UNITED STATES PATENT AND TRADEMARK OFFICE

Office Action Summary	Application No. 10/565,395	Applicant(s) RUTYNOWSKI, WLODZIMIERZ	
	Examiner JONATHAN W. MILES	Art Unit 3731

2. Claims 8-23 are rejected under 35 U.S.C. 103(a) as being unpatentable over **Thorne, Jr. et al. (US 6,358,265 B1)** in view of **Czernecki et al. (US 5,356,420)**.

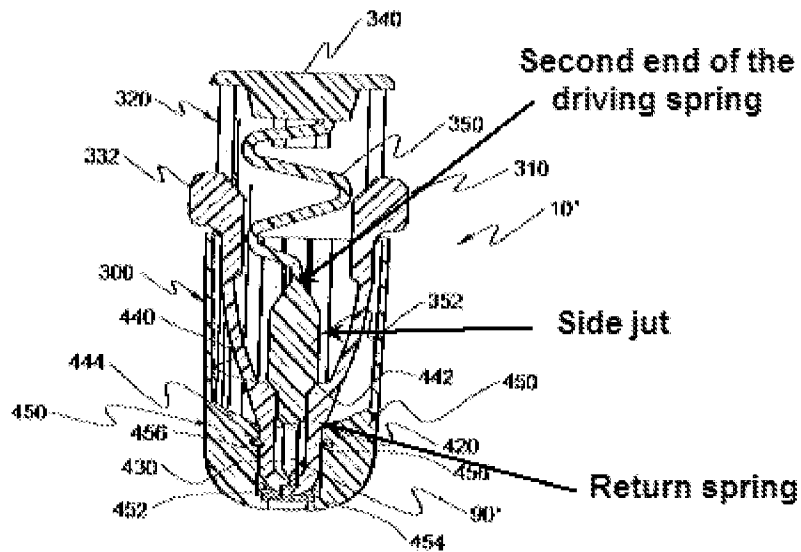
wherein the side jut (**354**), which is positioned inside the device longitudinally between the return spring and the second end of the driving spring (figures 23 and 17-20, please refer to the figure below)

such that the return spring, side jut, and driving spring are disposed in series along the longitudinal axis before, during, and after use of the puncturing device (figures 17-20, where “series” is taken to mean “arranged one after the other in succession”), and

wherein the return spring acts against the side jut in a direction opposite the driving direction,

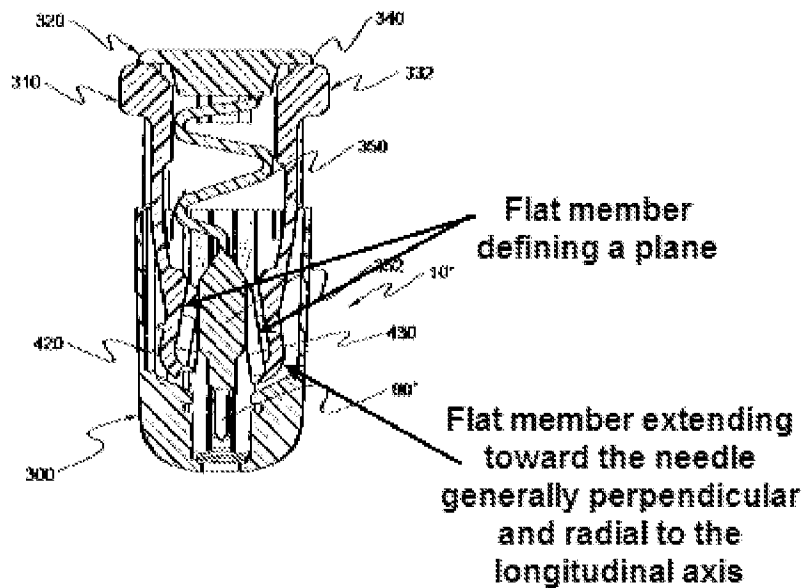
Claim 10: Thorne, Jr. et al. disclose a device as stated above wherein the return springs (420) are connected approximately perpendicularly to the lower portions of the arms (400) of the push button (340; figure 22), wherein each of the return springs comprises a flat member defining a plane and wherein the flat member extends toward the puncturing needle such that the plane of the flat member is generally perpendicular and radial to the longitudinal axis (please refer to the figure below).

wherein the puncturing needle has a first end driven by the driving spring and a second end comprising a puncturing portion, wherein the at least one side jut is disposed on the puncturing needle proximate to the first end of the puncturing needle and proximate to the second end of the driving spring (figure of claim rejection 10).
